# UNITED STATES PATENT AND TRADEMARK OFFICE

10/761,185

**Office Action Summary**

## **DETAILED ACTION**

FIG. 1

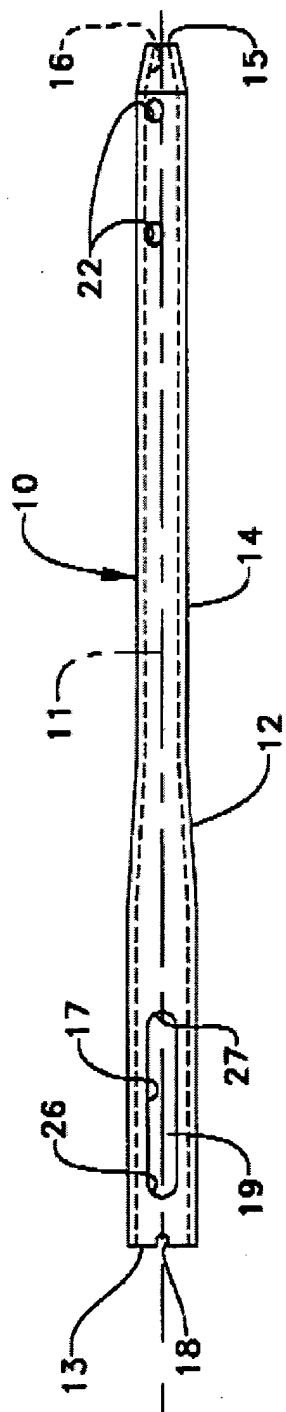
Border discloses an intramedullary nail for use with a first fastener and a second fastener for use in orthopedic surgery, said nail comprising a body (Fig. 1, 10) defining a longitudinal axis thereof, the body defining an aperture (Fig. 1, 16) therethrough, the aperture having a first portion (Fig. 1, 17) capable of cooperation with a first fastener to provide dynamic fixation and having a second portion (Fig. 1, 22) capable of cooperation with a second fastener to provide static fixation. The definition of axis, according to the Merriam-Webster Online Dictionary, is “a straight line about which a body or a geometric figure rotates or may be supposed to rotate.” Since the nail can rotate in any direction around any line or point where the nail exists in space, the axes can be anywhere in the body of the nail, in any orientation. This definition of axis will be applied throughout this office action. The “portions” can be considered part of the slot since they are continuous with the slot.

The slot (Fig. 1, 16) has a rectangular central section. As seen in Fig 1, the cross section of the middle of the slot has a rectangular section. It also has a cylindrical end

section (Fig. 1, 26) adjoining the rectangular central section. The cylindrical end section is capable of matingly fitting with the first fastener. The cylindrical end section is capable of slidable fit and threadable fit with the first fastener. The definition of thread, according to the Merriam-Webster Online Dictionary, is "to pass something through in the manner of a thread". The end is capable of threadable fit with the first fastener, since the screw could be placed through the end section. The aperture is capable of providing for a slidable fit of the first fastener with the body along the longitudinal axis of the body. If the diameter of the fastener's body is smaller than the diameter of the aperture, there would be room enough for the screw to slide in the aperture. The slot further includes a second cylindrical end section (Fig. 1, 22) opposed to the first mentioned cylindrical end section. The nail includes a resorbable component (Fig. 1, 19) for cooperation with said body adjacent the aperture. The resorbable component comprises external threads formed thereon (column 4, lines 31-35). The slot defines a slot axis thereof, the slot axis being perpendicular to the longitudinal axis of said body.

Border further discloses an intramedullary nail for use in orthopaedic surgery, said nail comprising: a body (Fig. 1, 10) defining a longitudinal axis and a transverse axis thereof, the transverse axis being normal the longitudinal axis, the body defining an aperture (Fig. 1, 16) therethrough, the aperture being substantially longer in the longitudinal axis than in transverse axis. The aperture is longer in some directions than others, and, applying the definition of axis, the axis can exist anywhere the nail is and in any direction. The aperture defines an enlarged portion (Fig. 1, 17) thereof along the longitudinal axis. Enlarge is defined by the Merriam-Webster Online Dictionary as "extend." It is longer in one direction than the other (Fig. 1, 17), hence it is extended in one direction and enlarged. The aperture has a rectangular central section. As seen in Fig. 1, the cross section of the middle of the slot has a rectangular section. The enlarged portion forms a generally cylindrical section and is positioned adjacent an end of the aperture. Viewing the enlarged portions from above the nail, as in Fig. 1 and Fig. 5, they have a generally cylindrical shape. Border discloses a fastener (Fig. 3, 34) capable of cooperation with the body. The cylindrical section of said body is capable of matingly fitting with said fastener. The cylindrical section is capable of slidable and threadable fit with said fastener. The aperture is capable of a slidable fit with the fastener with said body, along the longitudinal axis of said body. The aperture further includes a second enlarged cylindrical section (Fig. 1, 22) opposed to the first mentioned cylindrical section. Border discloses a resorbable component capable of cooperation with said body adjacent the aperture (Fig. 1, 19). The resorbable component comprises external threads formed thereon (column 4, lines 31-35). The enlarged

In response to the applicant's argument that the Border reference does not disclose an aperture that has a portion that can be used with a fastener to create static fixation, the examiner respectfully disagrees. The aperture of Border (Fig. 1, 16) is the longitudinal bore that extends through the nail from end to end (column 2, lines 33-35). Slot 17 and bores 22 are continuous with the aperture 16, as shown in Fig. 3. Thus, the

slot 17 and bores 22 can be considered to be part of aperture 16. The slot 17 can be considered to be the first portion of aperture 16, and bores 22 can be considered to be the second portion of the aperture. The first portion (slot 17) can contain resorbable material through which a fastener such as a bone screw can be placed (column 3, lines 38-49), which can be used in dynamic fixation (column 3, lines 49-52). The second portion (bores 22) do not include the resorbable material, and could be used to statically fix two bone fragments. One fastener could be placed through one bore 22 into one bone fragment and another fastener could be placed through the second bore 22 into a second bone fragment.

FIG. 3

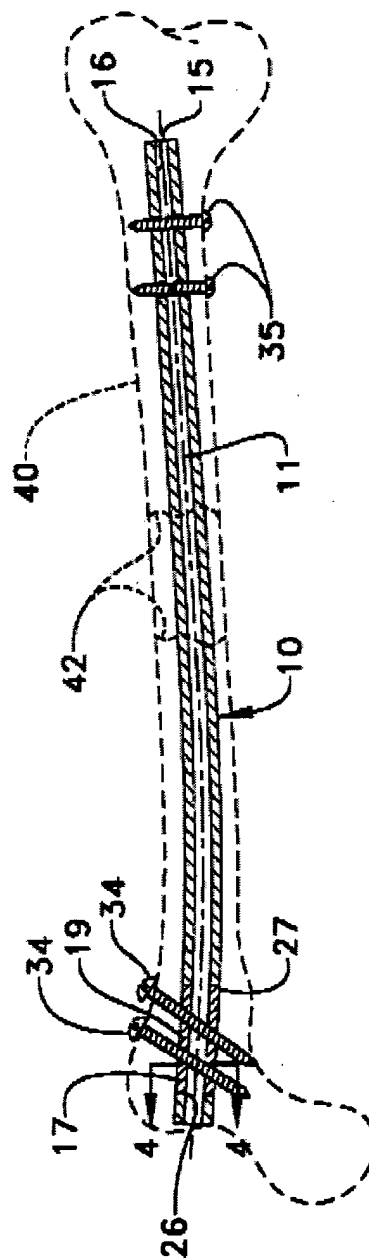
Border further discloses a kit for use in orthopedic surgery, the kit comprising: a first fastener (Fig. 3, 34); a second fastener (Fig. 3, 34); and an intramedullary nail comprising a body (Fig. 1, 10) defining a longitudinal axis thereof, the body defining an aperture therethrough (Fig 1, 16), the aperture having a first portion (Fig 1, 17) capable of cooperation with said first fastener to provide dynamic fixation and having a second portion capable of cooperation with said second fastener to provide static fixation (Fig. 1, 22). The slot has a rectangular central section. As seen in Fig 1, the cross section of the middle of the slot has a rectangular section. It also has a cylindrical end section

Fig. 9

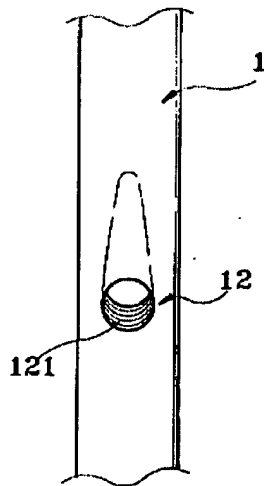
Emilio et al. disclose the body adjacent the first mentioned cylindrical end (Fig. 12 below, 130) defining internal threads therein (Fig. 12, 131) and the body adjacent the second cylindrical end (Fig. 12, 140) defining internal threads therein (Fig. 12, 141) (see also Fig. 9 below), for engagement and guiding of screws (Column 5, lines 19-24).

Fig. 12

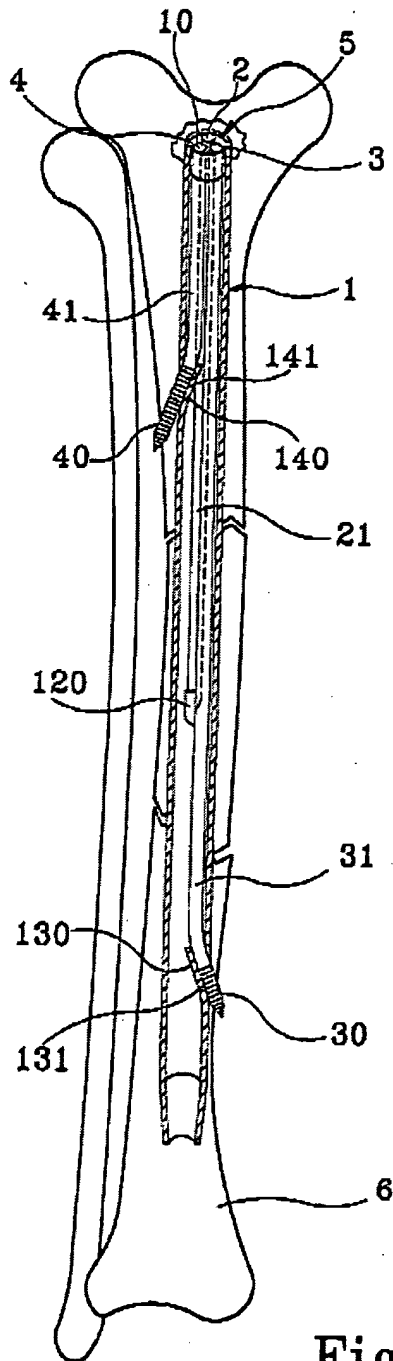
It would have been obvious to a person having ordinary skill in the art at the time the invention was made to construct the body adjacent the aperture of Border with the

internal threads of Emilio et al., in order for the internal threads to engage and guide screws used to fasten the nail to the bone (Column 5, lines 19-24).
